JT's Non-Confidential Response to
the JCRA's 5G spectrum award: Draft
Invitation to Tender (case T-064)

19th August 2022

Figure 3: JT's proposed alternative initial allocation 1 [Source: Analysys Mason, 2022]

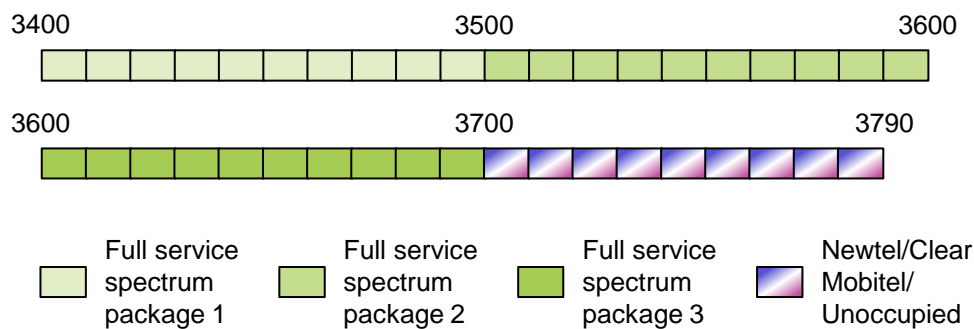
JT's preferred solution would be to re-farm/defragment immediately, enabling assignment of three contiguous 100MHz blocks in the 3.4–3.7GHz range, see Figure 3.

- Sure would be required to relinquish its current assignment of paired spectrum (which, in its current form, is not compatible with 5G deployment). As suggested in Section 3.2, JT believes that this should be a condition of Sure's application. JT understands that Sure is currently not using its spectrum and, as this is the case, we do not see a reason to wait "at least five years" for the spectrum to be returned. Additionally, Sure is

- Newtel would be moved to the upper portion of the band. The exact configuration that the upper band would take is unclear, but there is certainly space for Newtel's 2×20MHz to be located here. As Newtel is currently using its FWA spectrum, any solution must support its continued use, at least in the short term, and hence we note JCRA will need to engage with Newtel to understand its network and device capabilities in order to determine a viable alternative assignment. Again, JT advocates for a one-year notice period, as described in CICRA's Draft ITT.

- Clear Mobitel returns its current assignment, enabling 50MHz in the 3700–3790MHz range to be made available for Limited Service Spectrum Packages, or new entrants. As Clear Mobitel is not currently using its spectrum, we do not see a reason to wait "at least five years" for the spectrum to be returned. If Clear Mobitel intends to deliver 5G services, then it should be willing to co-operate as its current assignment is non-contiguous and only licensed for FWA. Alternatively, if Clear Mobitel does not voluntarily relinquish its spectrum, its FWA holdings could be shifted into the remaining 60MHz of the 3.7–3.8GHz band, provided that the top 10MHz (3790–3800MHz) is available, and contingent on requirements for guard bands with Newtel's holdings¹² (and the required separation between Clear Mobitel's uplink and downlink blocks).

Figure 4: JT's proposed alternative initial assignment 2 [Source: Analysys Mason, 2022]

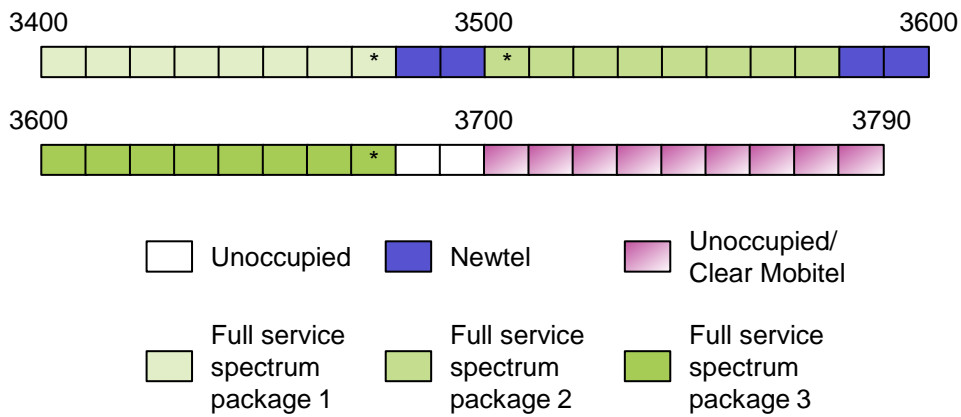
Figure 4 illustrates JT's second preferred alternative approach, which allows all three full-service spectrum packages to have an initial assignment of 80MHz (or 70MHz in the event that guard bands are required around Newtel's downlink spectrum).

- Newtel's current spectrum assignment remains unchanged (3480–3500MHz, 3580–3600MHz)
- Sure relinquishes its current holdings, on the basis that it is assumed Sure will be applying for a 5G licence in the 3.5GHz band
- either Clear Mobitel relinquishes its current holdings, or if it is not incentivised to do so, its blocks of spectrum are relocated into the 3700–3790MHz range.

This approach is contingent on Clear Mobitel either voluntarily relinquishing its spectrum, or agreeing to change the location of its existing spectrum.
